FINDINGS OF FACT, CONCLUSION OF LAW AND ORDER

In the matter of the application of:
Bernal Landing Subdivision - SD2026-0003

PLANNING DIVISION STAFF REPORT

BERNAL LANDING
PRELIMINARY PLAT

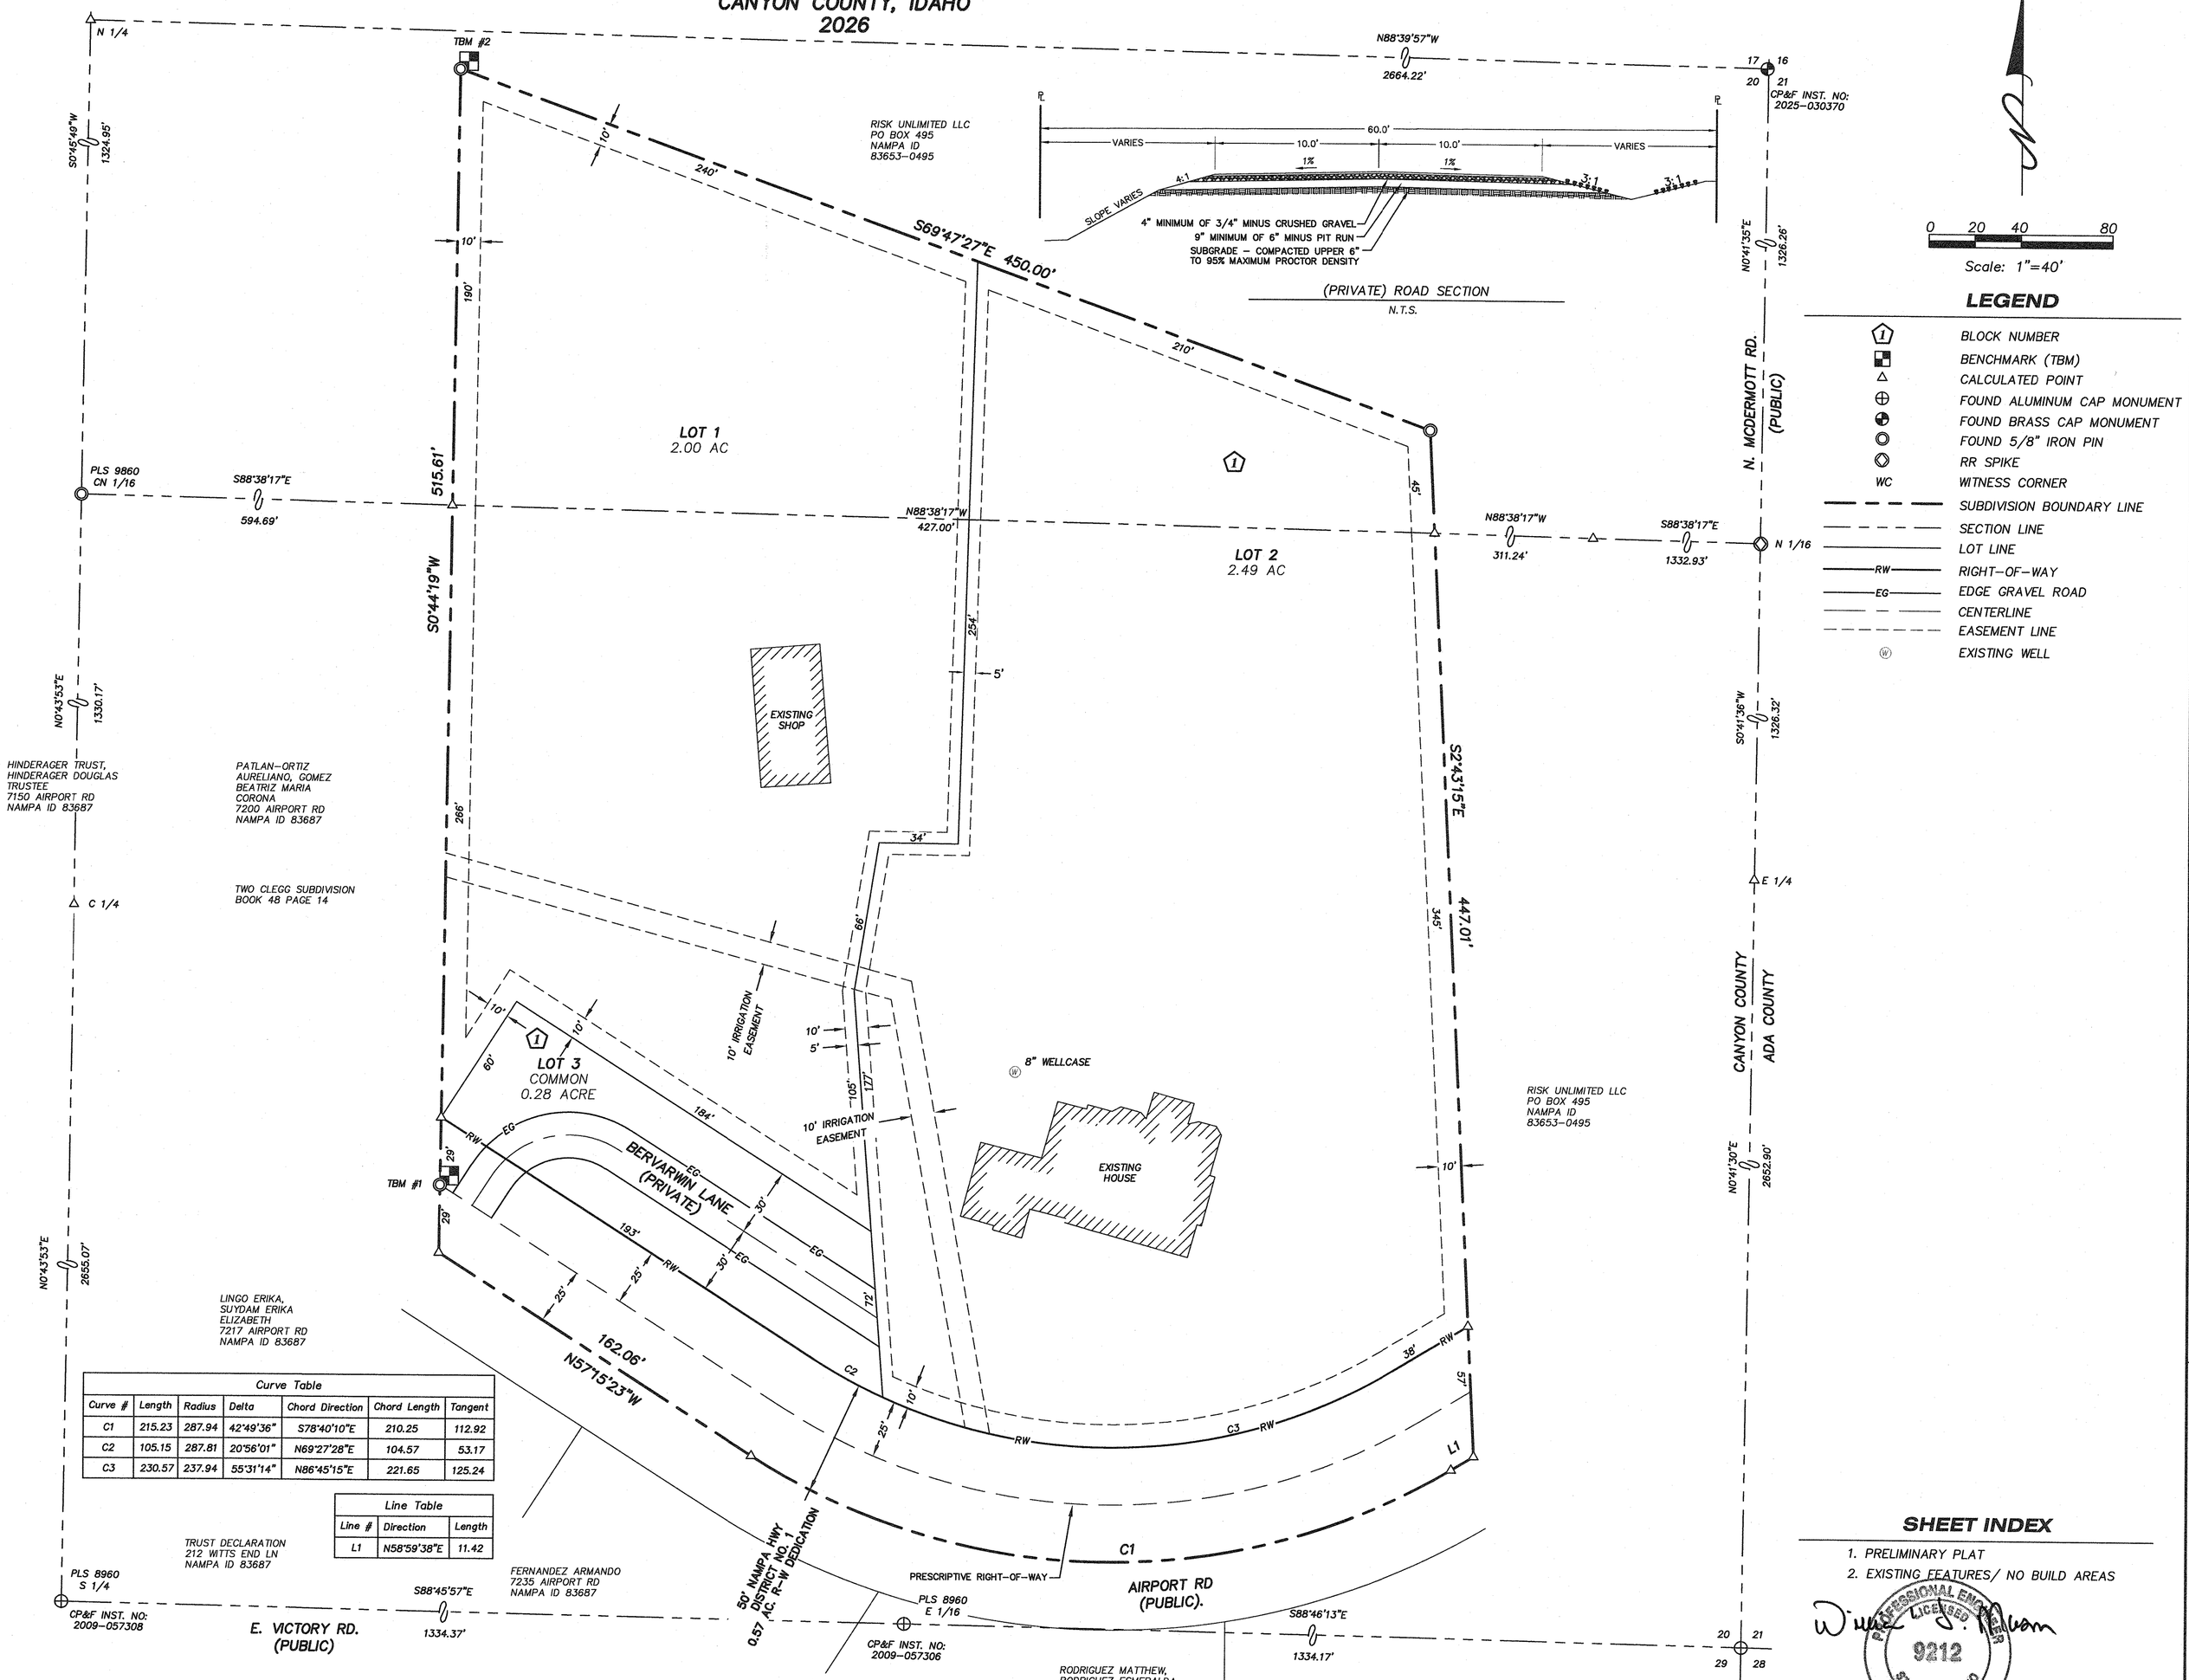
1. The ingress/egress easement through Lot 1 to the back of Lot 2 has been removed.
2. A private road common lot has been added and the easement for it widened to 60'.
3. Curve C3 dimensions have been added to the curve table.
4. Utility and irrigation easements have been clearly dimensioned and marked.
5. Lot count in the project narrative has been updated.

BERNAL LANDING
EXISTING FEATURES/ NO BUILD AREAS

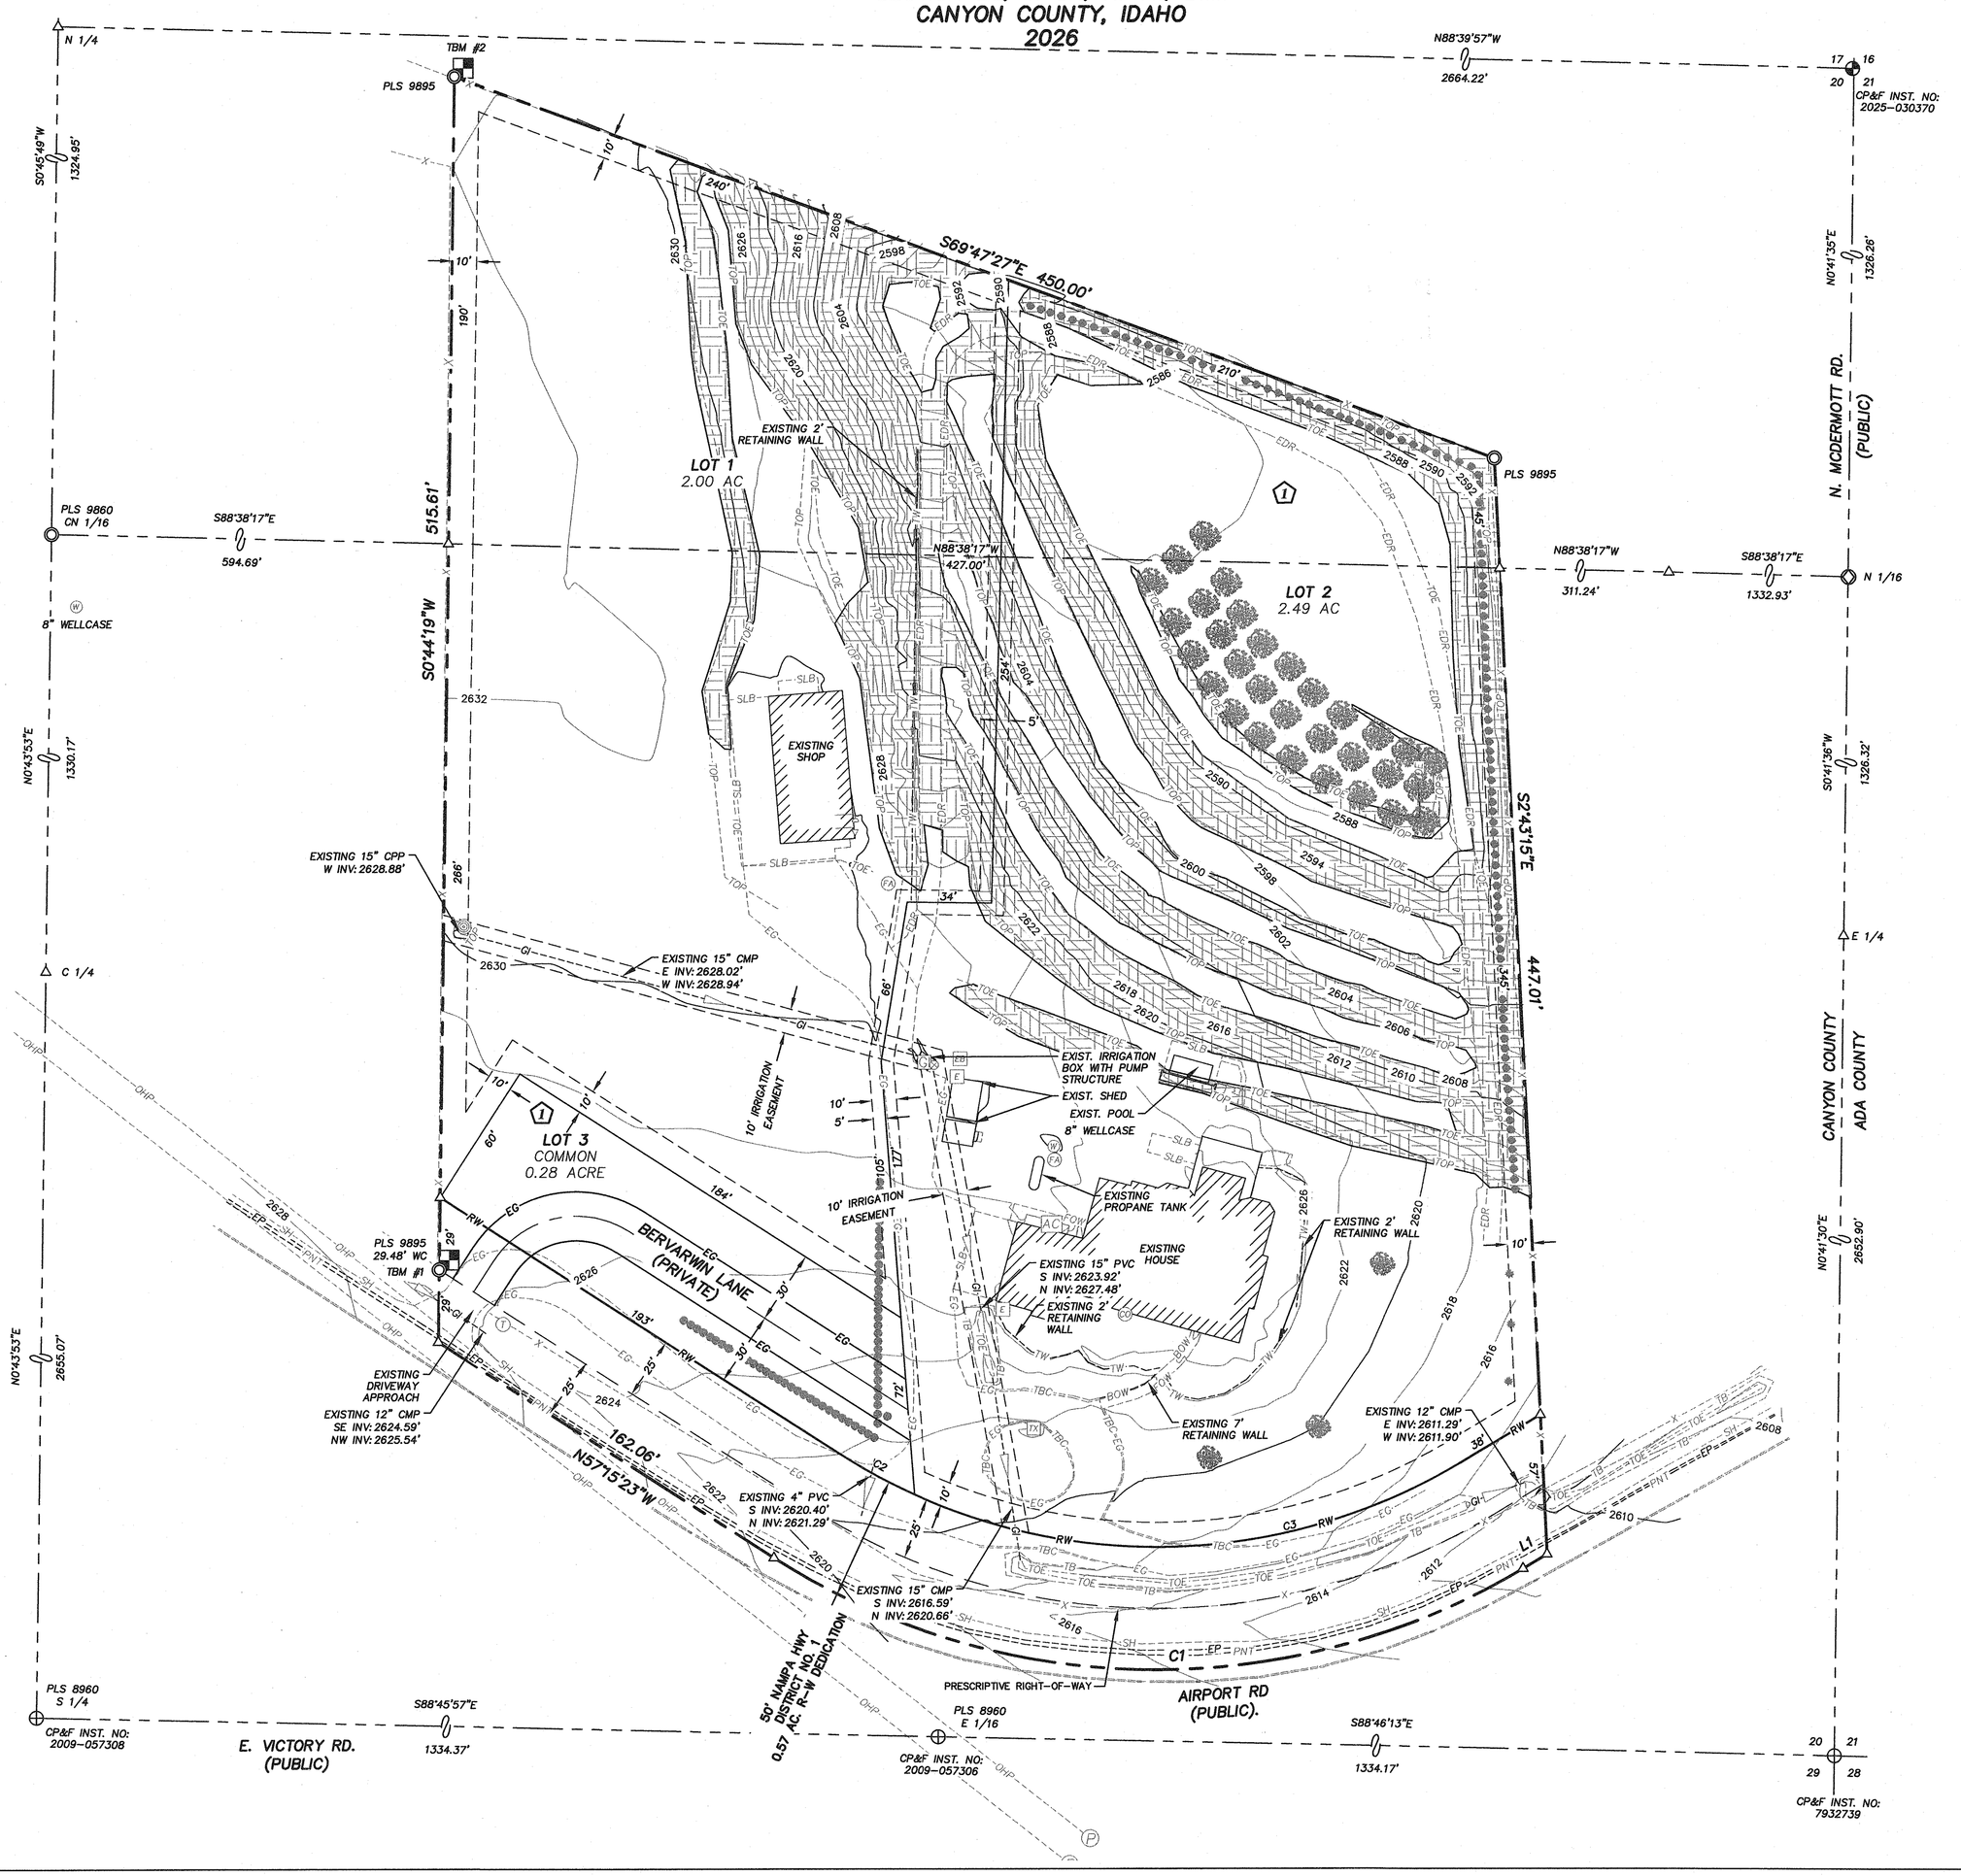
2nd review: Compliant. The preliminary plat (Sheet 2) includes crosshatch shading to designate non-buildable areas with slopes of 15% on the northern/eastern portion of the property.
